Strathfield Internal Development Assessment Panel Meeting

Friday, 15 November 2019

SUBJECT: DA2018/124/02 - 14 MERLEY ROAD, STRATHFIELD
LOT 3 IN DP 236123

Proposal: Section 4.55(2) modification application to amend approved alterations and additions by extending rear terrace and garden shed.

Figure 3: Ground floor plan illustrating the original approved development (yellow) and proposed amendments (fuchsia).

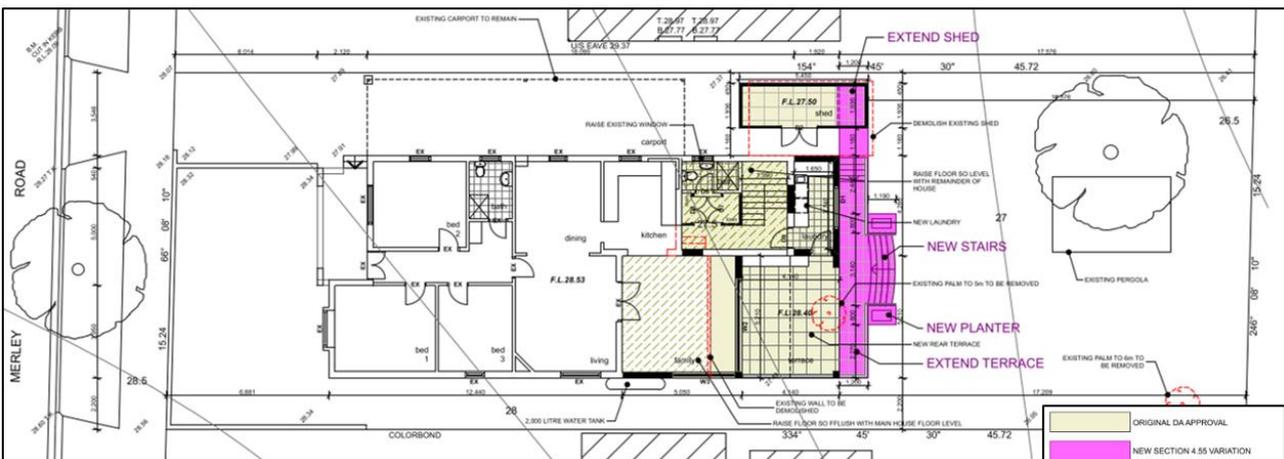
- Increase the size of the detached shed from 6.7m² to 8.8m²;
- Increase the size of the rear terrace area; and
- Internal re-configuration of the laundry.

In regard to subclause ‘a’, Council is satisfied that the development to which the consent as modified relates is substantially the same development for which consent was originally granted.

Figure 4: Eastern elevation plan illustrating the original approved development (yellow) and proposed amendments (fuchsia).

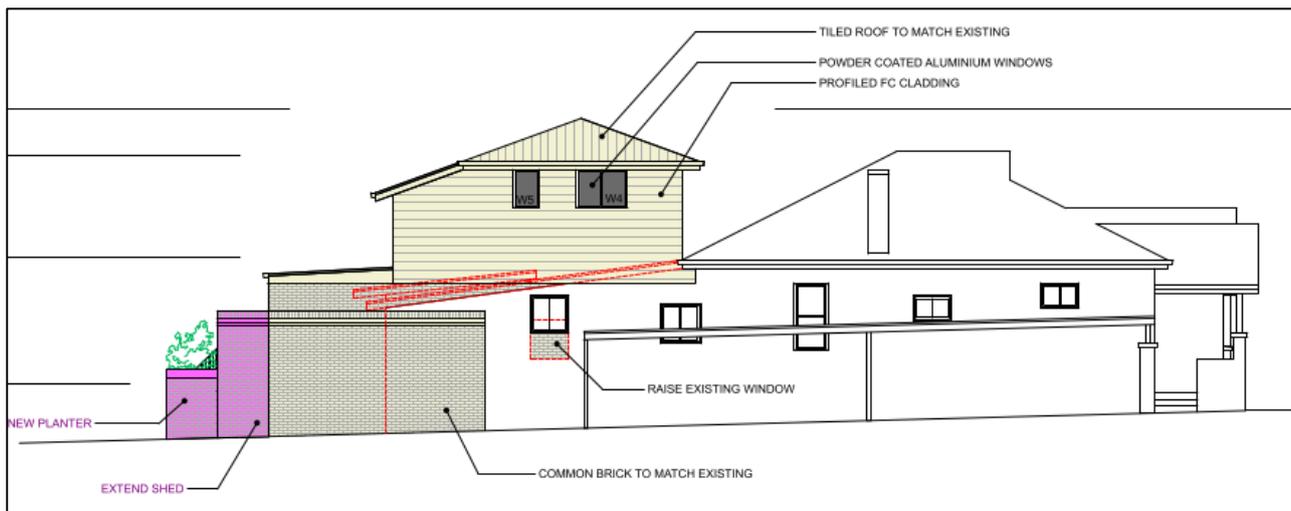
To answer this threshold question, a comparative analysis of the approved development as modified has been undertaken. In this regard, the proposed use as a dwelling does not change; the external building appearance as viewed from Merley Road is not altered in a discernible manner; and amenity impacts to neighbouring development in terms of privacy, views, solar access and

Figures 2 and 3: Southern-most units on Levels 1-4 as per the approved development (left figure) and as per the proposed modification (right figure)

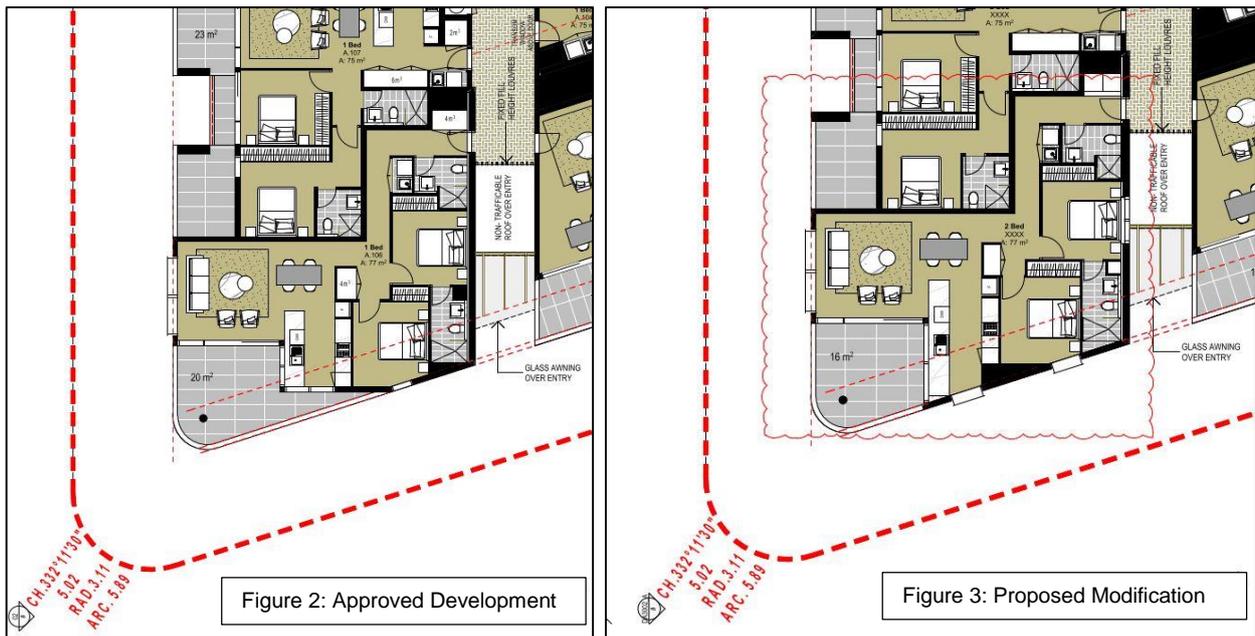
The changed layout and window arrangement of the units on Levels 1-4 are associated with some of the southern-most 2 bedroom units. Figure 2 below shows these units as approved. Figure 3 below shows the proposed modifications to these units.

As indicated on the above figures, a portion of the balcony space will be converted to provide additional internal area.

Figures 4 and 5: Northern portion of Level 6 as per the approved development (left figure) and as per the proposed modification (right figure)

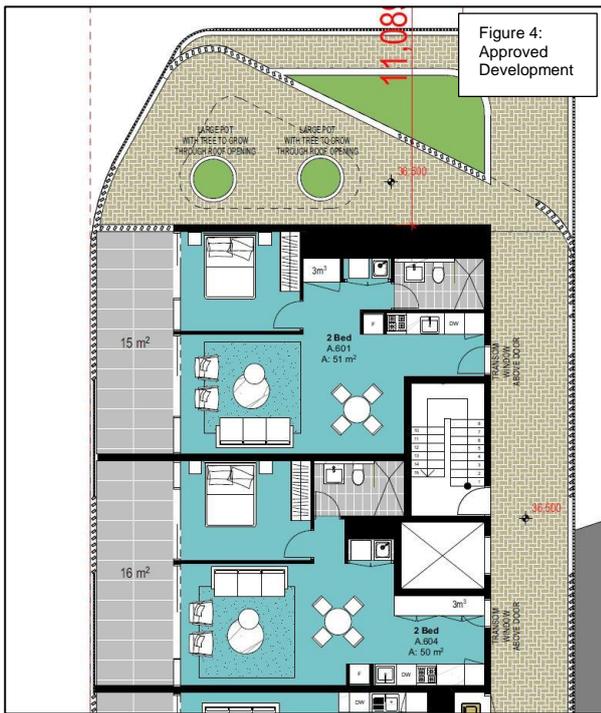
The remaining elements involve modifications to Level 6. Specifically, these involve consolidation of 2 of the 2 bedroom units (units A601 and A602) on the northern side to create a 3 bedroom unit and the conversion of the roof top communal open space into a private open space for this unit. Figure 4 below shows the above elements as approved. Figure 5 below shows the proposed modifications to these elements.

Figure 8: Tree removal/protection plan (Source: Arboriculture Impact Assessment, Australis Tree Management July 2019)

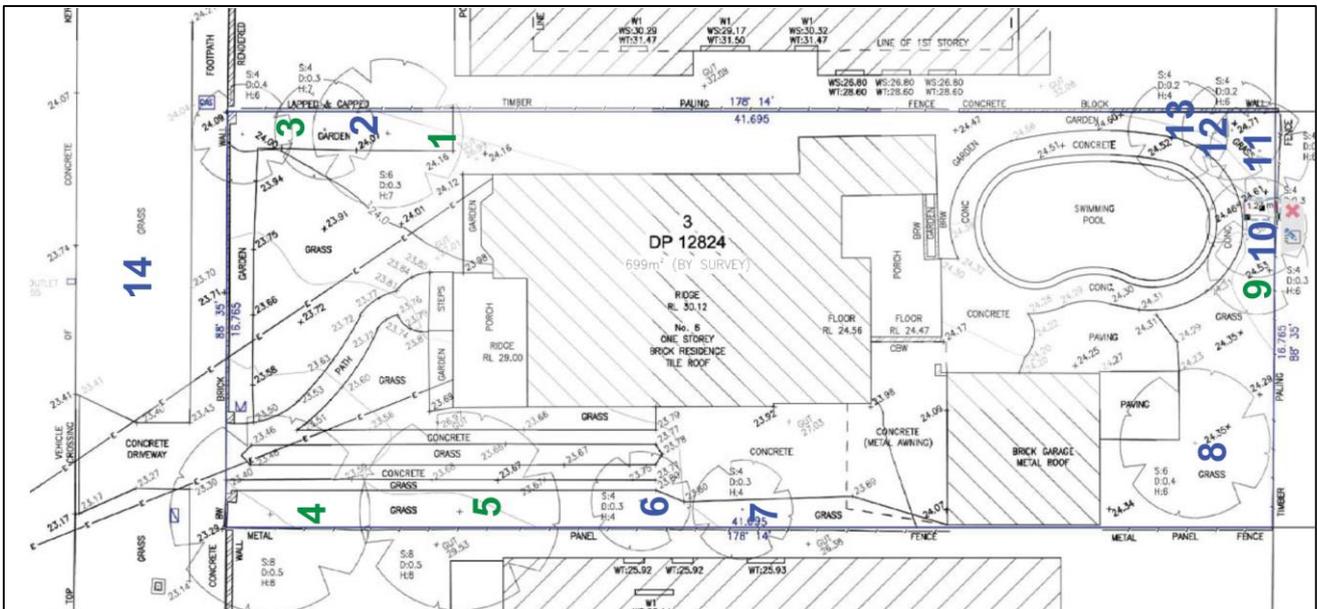
The proposed retention and protection of the trees numbered #1, #2, #3 and #4 are supported by Council's Tree Officer with conditions imposed to ensure they are protected in accordance with the submitted Arborist Report.

The proposed removal of the trees numbered #5, #6, #7, #8, #9, #10, #11 and #12 and #13 are also supported subject to two (2) replacement tree plantings in the rear and one (1) replacement planting in the front setback capable of achieving a minimum mature height of 10m. Relevant conditions of consent have been imposed to ensure compliance with the above requirements.

Figure 9: Streetscape elevation demonstrating heights of the proposed dwelling amongst existing development immediately adjoining the site.

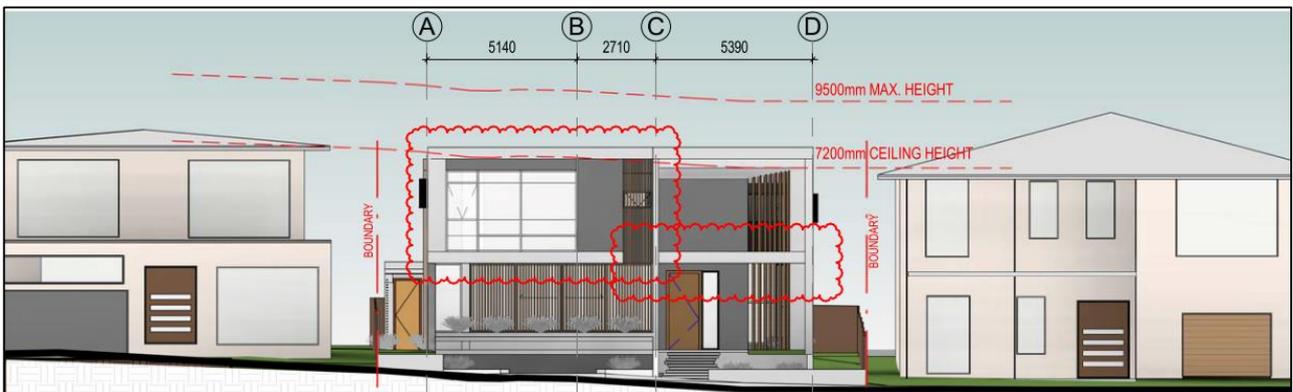
Comments: The proposed dwelling provides a maximum building height of 7.56m, thus achieving compliance with the maximum 9.5m building height standard. Accordingly, the development will be compatible with the surrounding building heights as shown in Figure 9.
